Access Compliance Report

Public Rights-of-Way

(Curb Ramps)

Intersection ID: 2878	Main Street: BROKEN_PINE_LN	Cross Street: LONG_FOREST_DR	Location: SE
ADA ID: 0C9CACA14543	Ramp Type: Perp	Initial Pass/Fail: Pass	Overall Compliance: No
		Severity Score: 0	
Codes/Mitigation Info/Possible Solution		Field Measurements/Component Compliance

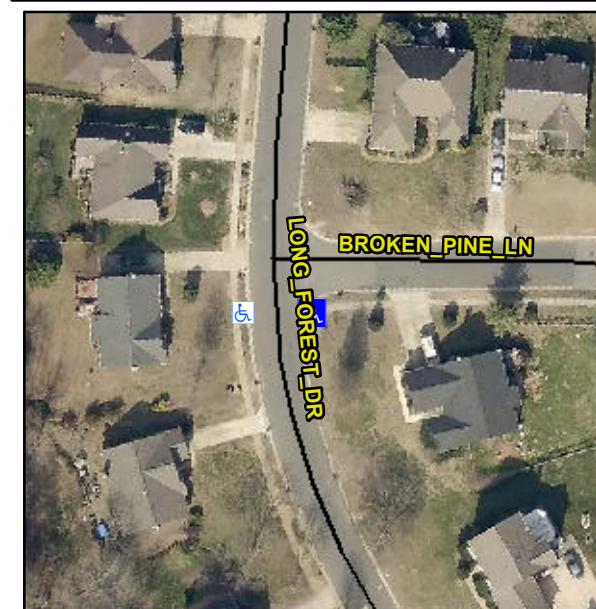
R304.2.1, R304.2.2-Perp, R304.3.2-Para, R305.2

Compliance	Description	Data	Compliance	Description	Data
N/A	Ramp Length (in)	52.0	Yes	Ramp Slope (%)	7.7
Yes	Ramp Width (in)	48.0	Yes	Ramp XSlope (%)	0.3
N/A	Flare Type LT	Sloped	N/A	Flare Type RT	N/A
N/A	Flare Slope LT (%)	15.5	N/A	Flare Slope RT (%)	16.1
N/A	Flare Traversable LT?	No	N/A	Flare Traversable RT?	No
No	Landing Length (in)	45.0	Yes	DWS Provided?	Yes
Yes	Landing Width (in)	48.0	Yes	DWS Contrast?	Yes
No	Landing Slope (%)	3.0	Yes	DWS Length (in)	25.5
Yes	Landing X Slope (%)	0.1	Yes	DWS Full Width?	Yes
N/A	Landing Curb? (Y/N)	No	No	DWS Offset (in)	4.0
N/A	Shared Landing?	No			
Yes	Gutter Ponding?	No	Yes	Gutter Slope (%)	1.4
Yes	Gutter Lip Ht (in)	0.0	Yes	Gutter X Slope (%)	0.3
N/A	Painted X Walk1?	No	N/A	Painted X Walk2?	N/A
	X Walk 1 Direction	To W		X Walk 2 Direction	N/A
N/A	X Walk 1 Width (in)	N/A	N/A	X Walk 2 Width (in)	N/A
	X Walk 1 Slope (%)	3.3		X Walk 2 Slope (%)	N/A
	X Walk 1 X Slope (%)	5.8		X Walk 2 X Slope (%)	N/A

Remove & Replace Entire Ramp.
